Re: **Docket No. 317** – The United Illuminating Company Application for a Certificate of Environmental Compatibility and Public Need for the Construction, Maintenance, and Operation of a Proposed 115-kV/13.8-kV Electric Substation and Associated Facilities Located at 3-7 Wildflower Lane, Trumbull, Connecticut. Revision to EMF Assessment.

EMF ASSESSMENT
FOR THE
PROPOSED TRUMBULL SUBSTATION

August 17, 2005
(Revised August 9, 2006)

August 9, 2006 Revision

Figure 15. Phasing Diagram for the Existing 115 kV Transmission Lines at the Proposed Trumbull Substation

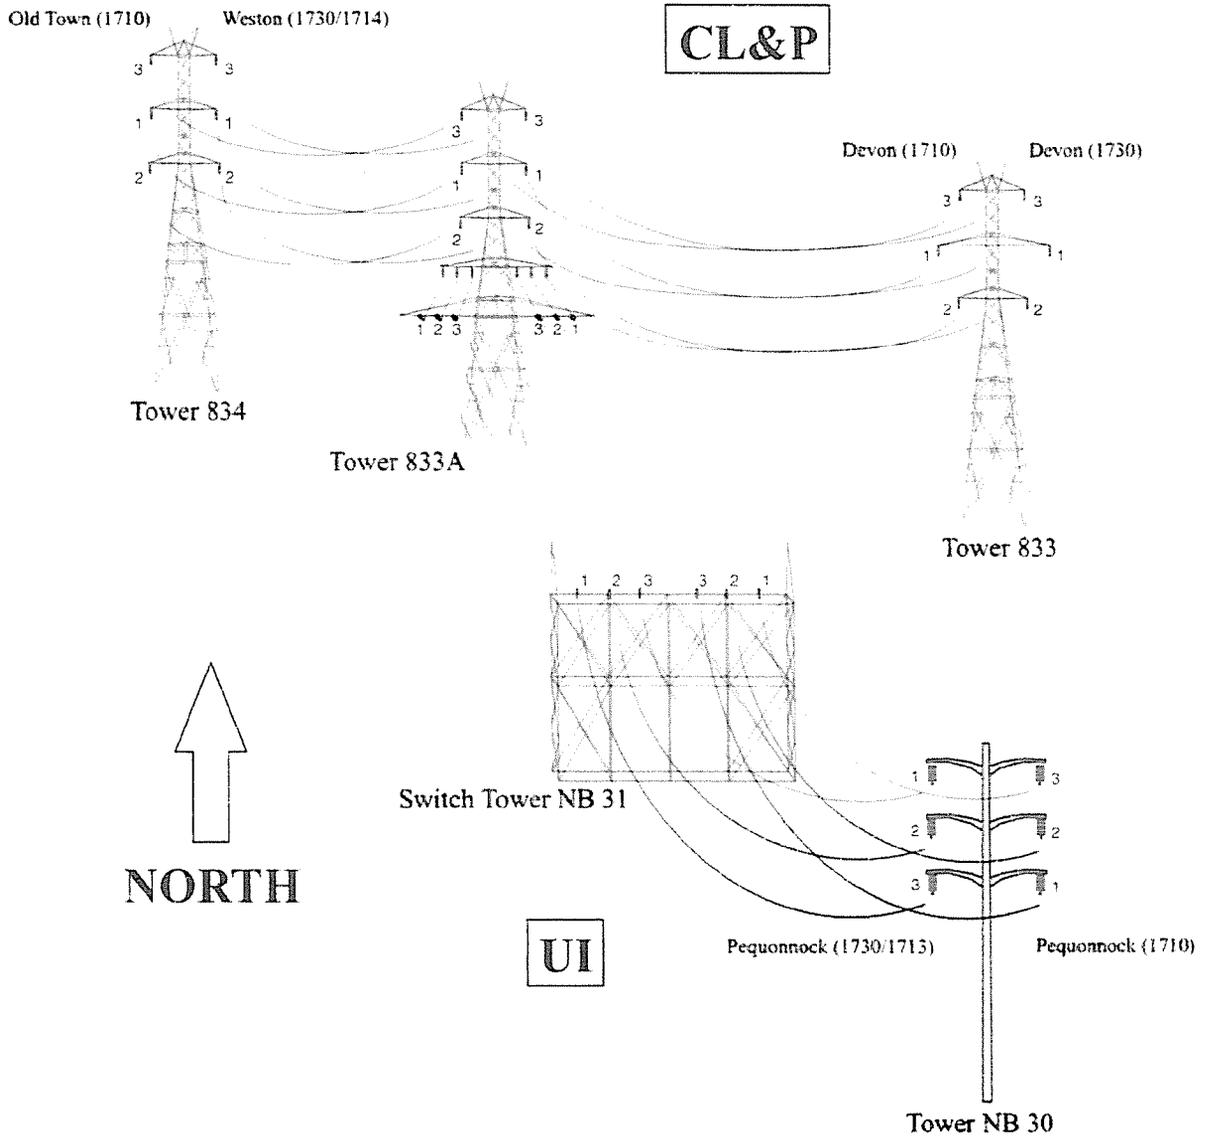
Subsequent to submitting the June 20, 2006 EMF Assessment report, a phasing difference was discovered on the CL&P 115 kV double circuit transmission line that is located north of the proposed Trumbull substation. A technical drawing from the 1960s appeared to indicate that the CL&P circuits have unlike (reverse) phasing and this was discovered to be incorrect. The UI 115 kV lines were applied as unlike phasing and this is accurate. This August 9, 2006 revision corrects the CL&P phasing and associated changes to the report. The effect of the CL&P phasing change is primarily limited to the area where the proposed Trumbull substation and CL&P easements abut. To clarify the effect of Like/Unlike phasing, calculations with both phasing arrangements of the CL&P circuits are included on Figure 16 (electric field) and Figure 17 (magnetic field). All other Figures in this revised report are based on Like phasing for the CL&P 115 kV circuits. The affected portions of the report are highlighted to facilitate identification of changes.
